Proposed Revisions to a Standard Plans Index

Index Number: 700-120
Sheet Number (s): All
Index Title: Enhanced Highway Signing Assemblies

Index Number: 700-120

Index Title: Enhanced Highway Signing Assemblies

ADDED NEW SHEETS

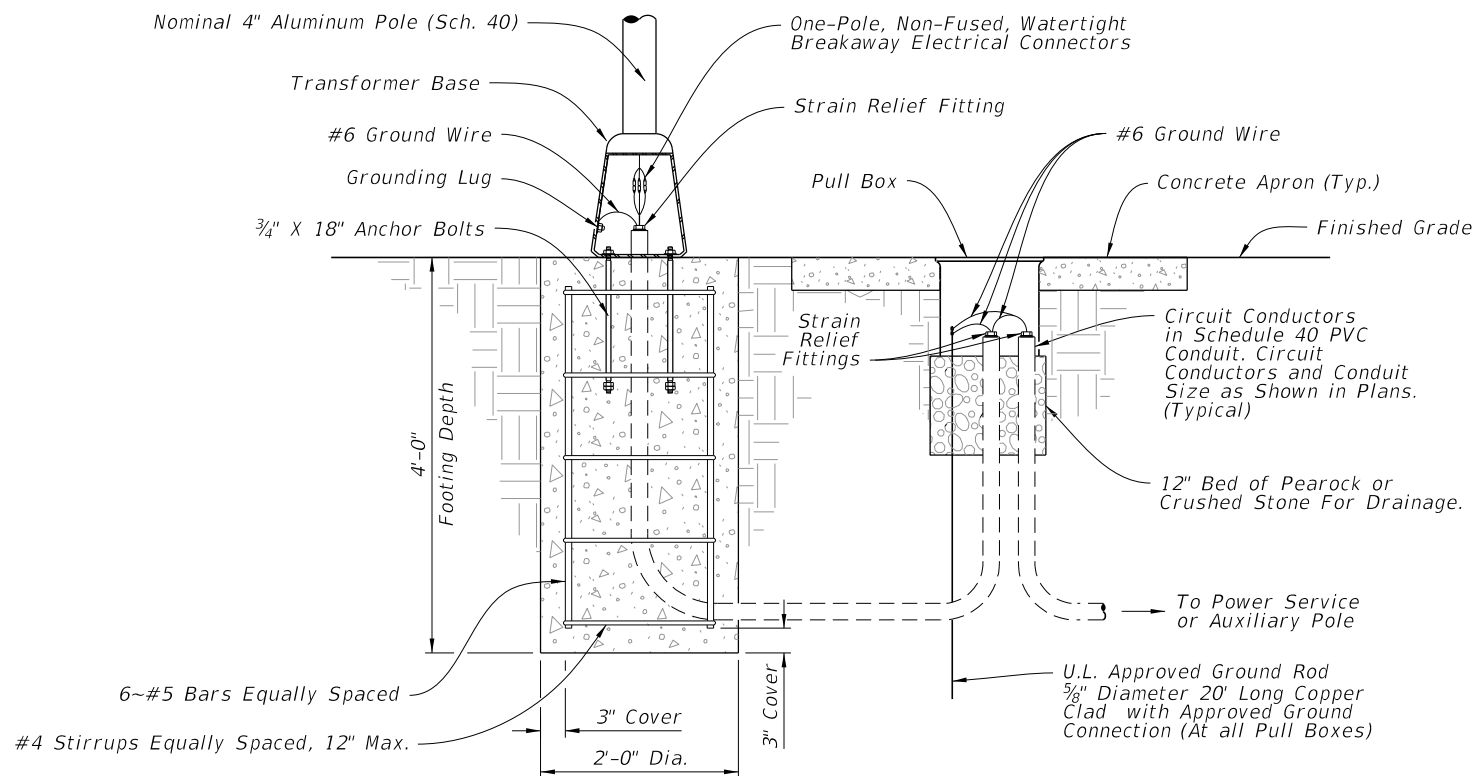
All Sheets: Renumber
Sheet 1: Added New Sheets to Table of Contents.
Sheet 3: New Sheet - Spread Footing Foundation.
Sheet 12: New Sheet - Roadside Sign Assembly-9.
Sheet 13: New Sheet - Roadside Sign Assembly-10.
Sheet 14: New Sheet - Roadside Sign Assembly-11.

TABLE OF CONTENTS:	
Sheet	Description
1	General Notes and Contents
2	Conduit, Wiring, and Foundation Details
3	Spread Footing Foundation
4	Roadside Sign Assembly-1
5	Roadside Sign Assembly-2
6	Roadside Sign Assembly-3
7	Roadside Sign Assembly-4
8	Roadside Sign Assembly-5
9	Roadside Sign Assembly-6
10	Roadside Sign Assembly-7
11	Roadside Sign Assembly-8
12	Overhead Sign Assembly-9
13	Roadside Sign Assembly-10
14	Roadside Sign Assembly-11
15	Overhead Sign Assembly

NEW SHEET 3

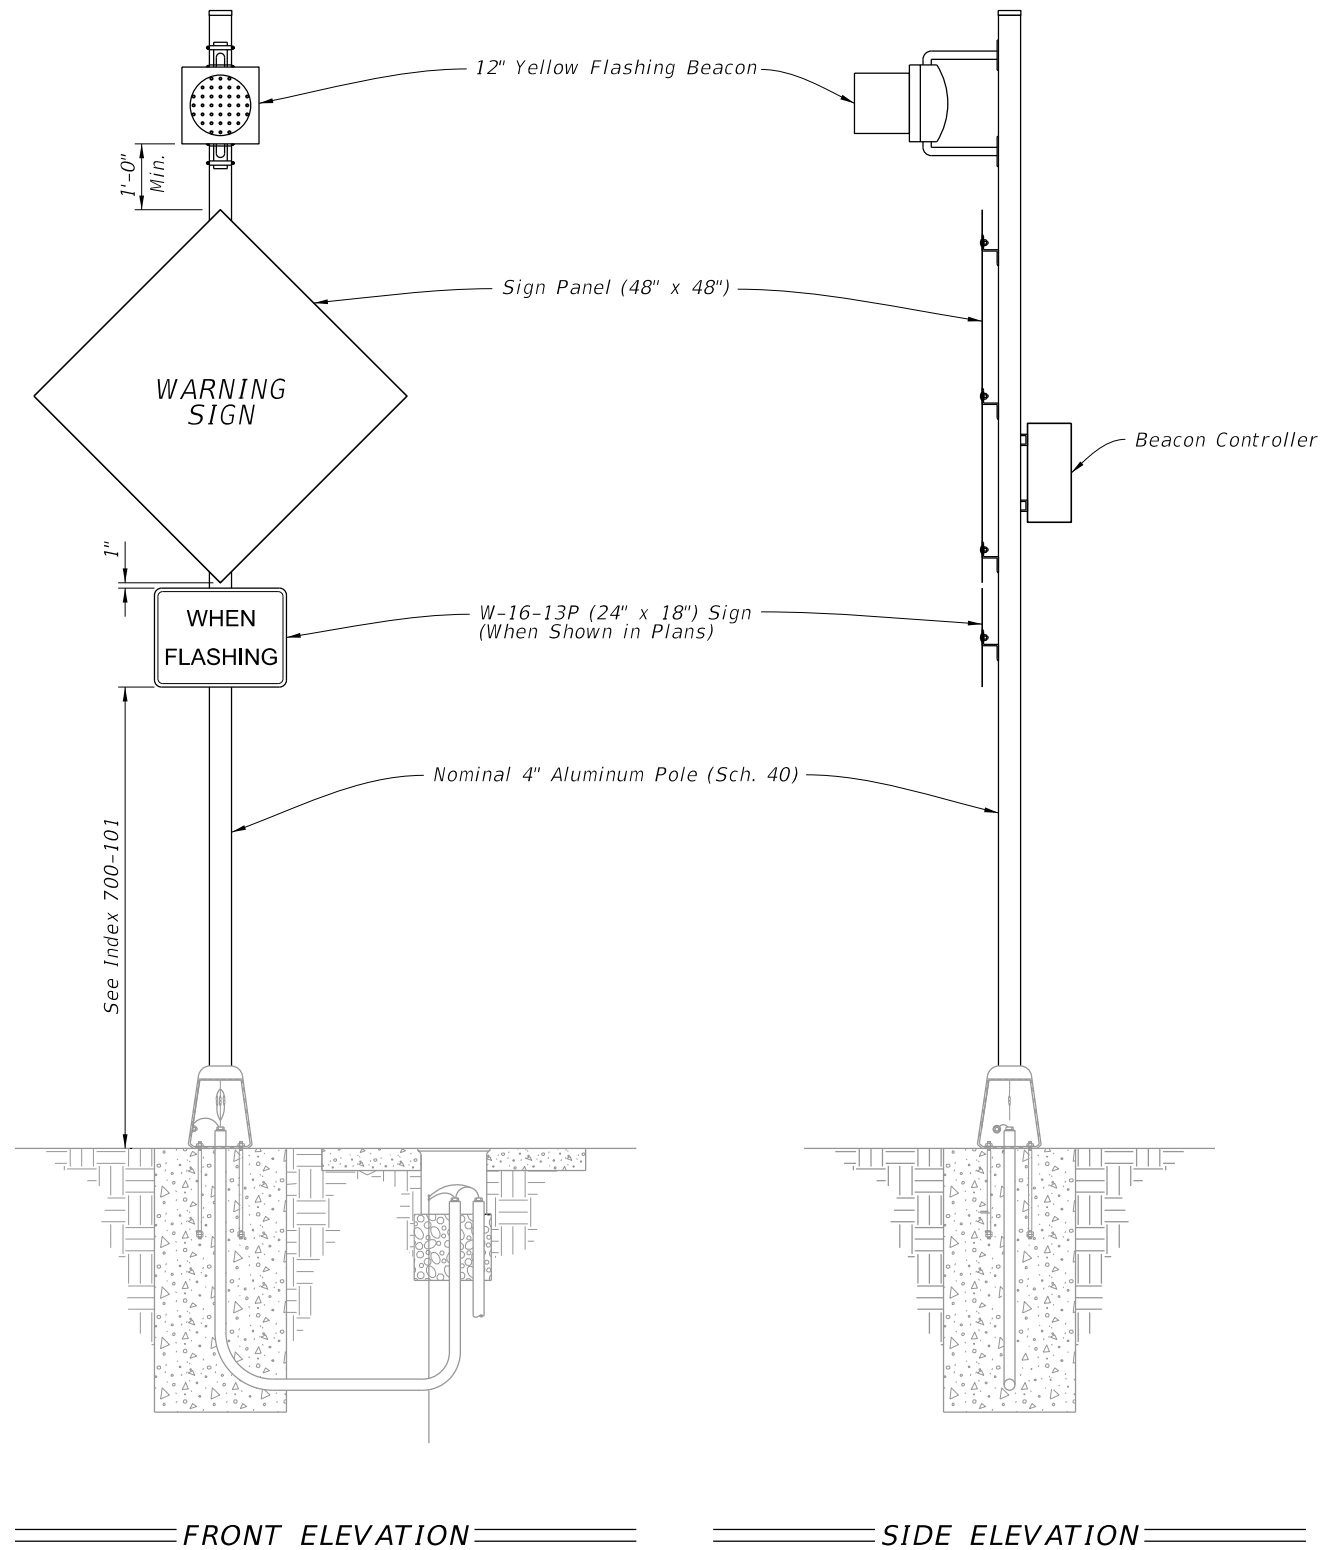
The districts have requested a spread footing foundation option be added.

NEW SHEET 12

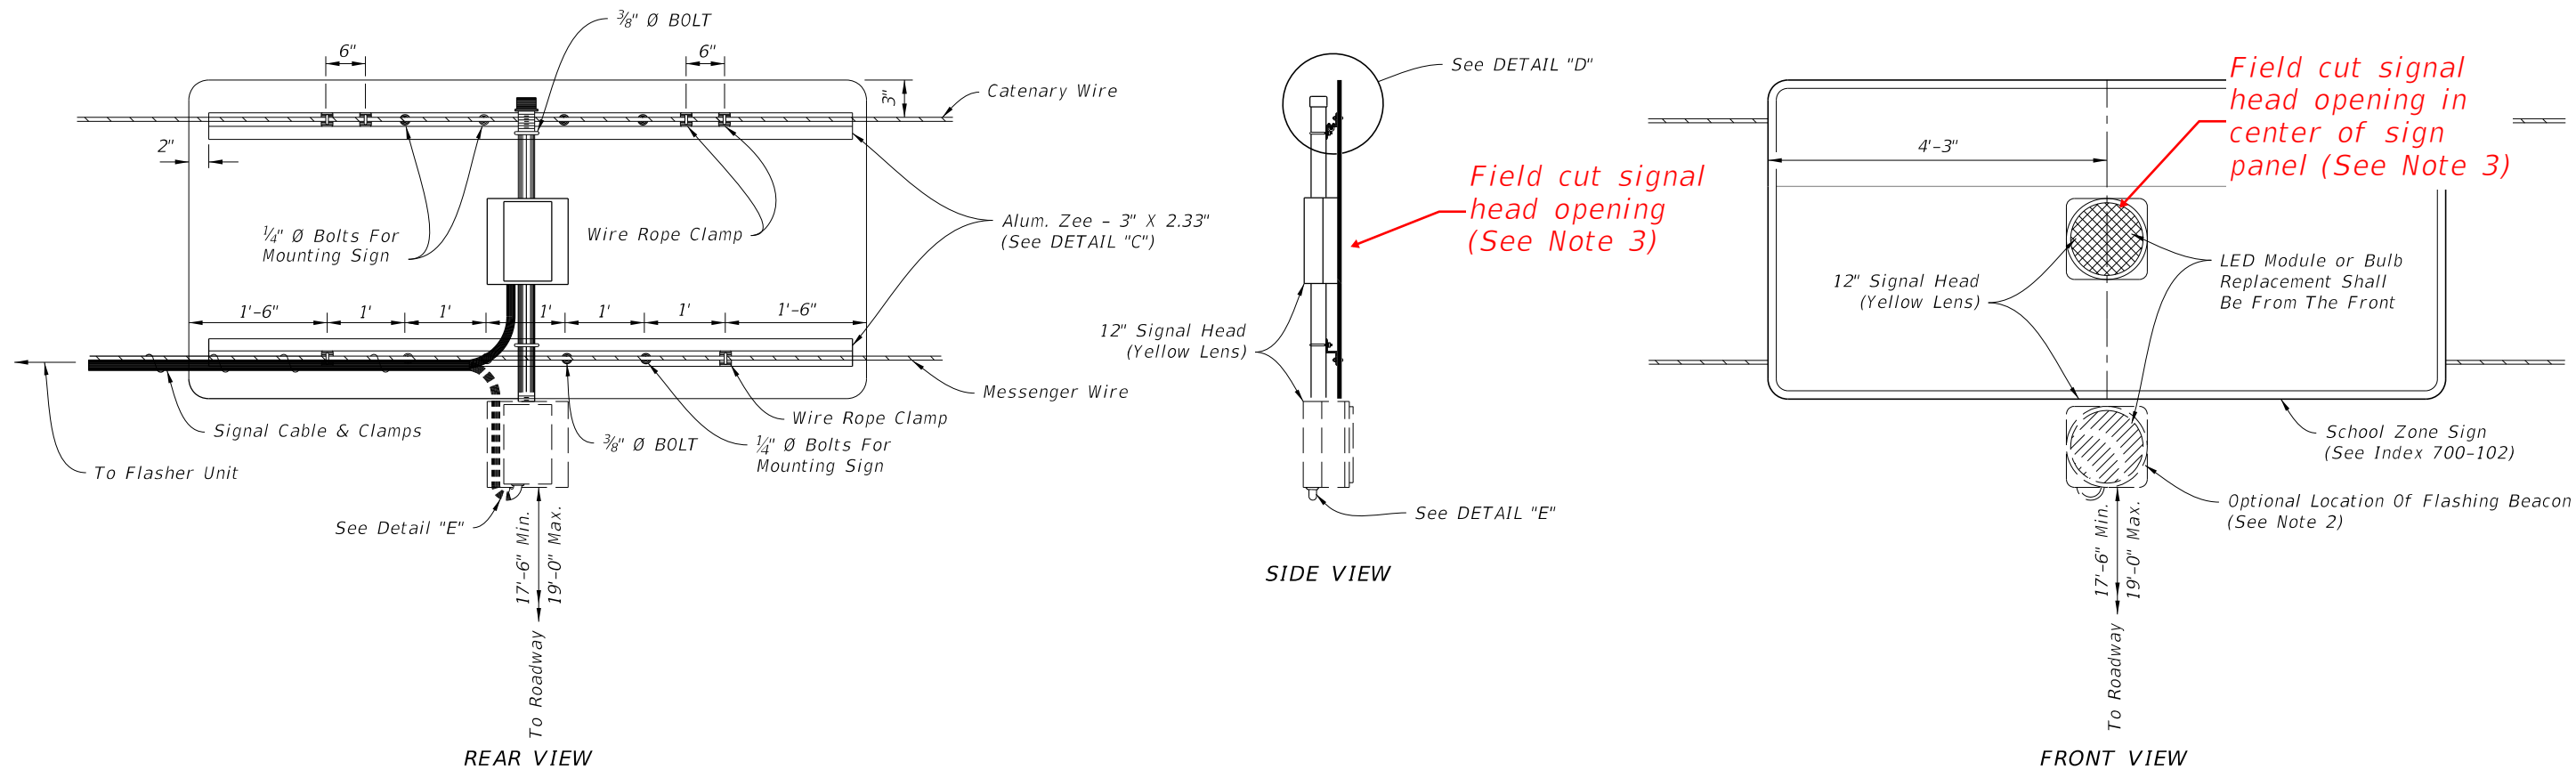
Three new Railroad Highlighted sign assemblies are being added as a result of input from the Rail Safety Task Team.

OVERHEAD SIGN ASSEMBLY

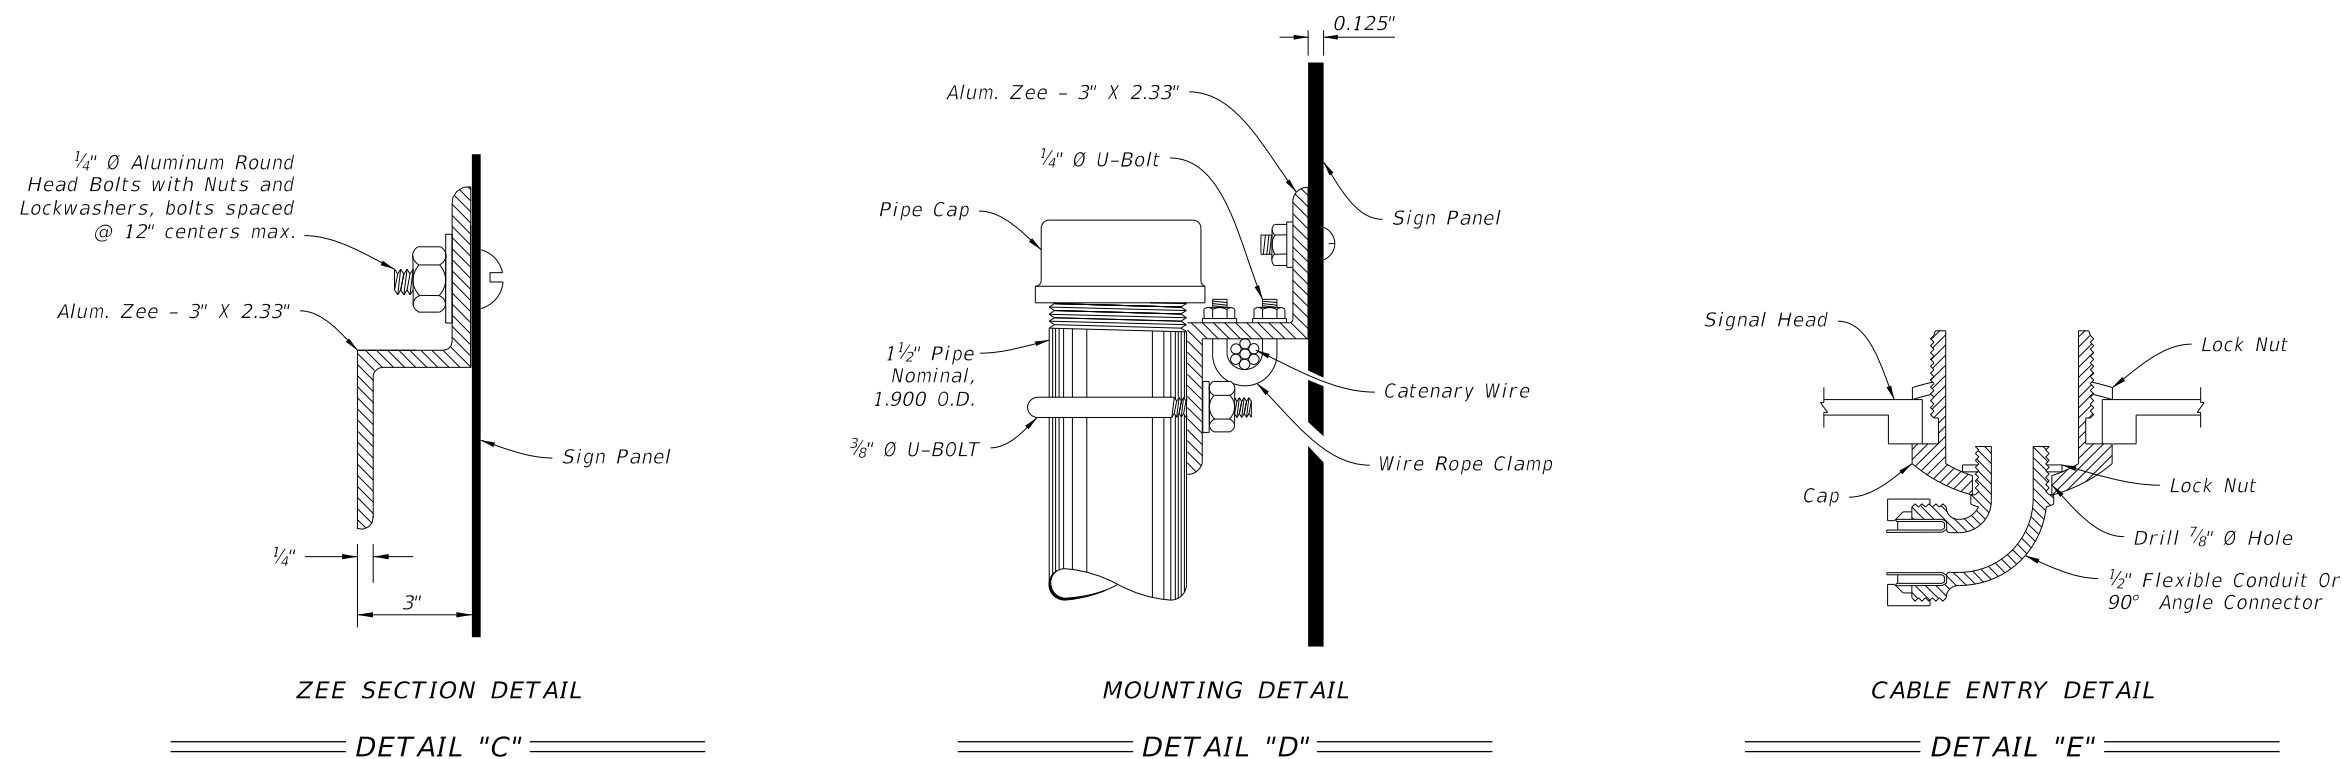
Added note 3 "Opening for 12" signal head shall be done in the field in accordance with the manufacturers specifications".

Added 2 call outs one on side view "Field cut signal head opening (See note 3) and the other for front view "Field cut signal head opening in center of sign panel (See Note 3).

- Flasher unit and cabinet to be placed on the strain pole supporting overhead sign assembly or on service pole. The flasher unit not to overhang private property or sidewalk.
- Optional flashing beacon will be called for in the Plans. They may be placed within or below the panel, or face to the rear.
- Field install the opening for 12" signal head in accordance with the manufacturers specifications
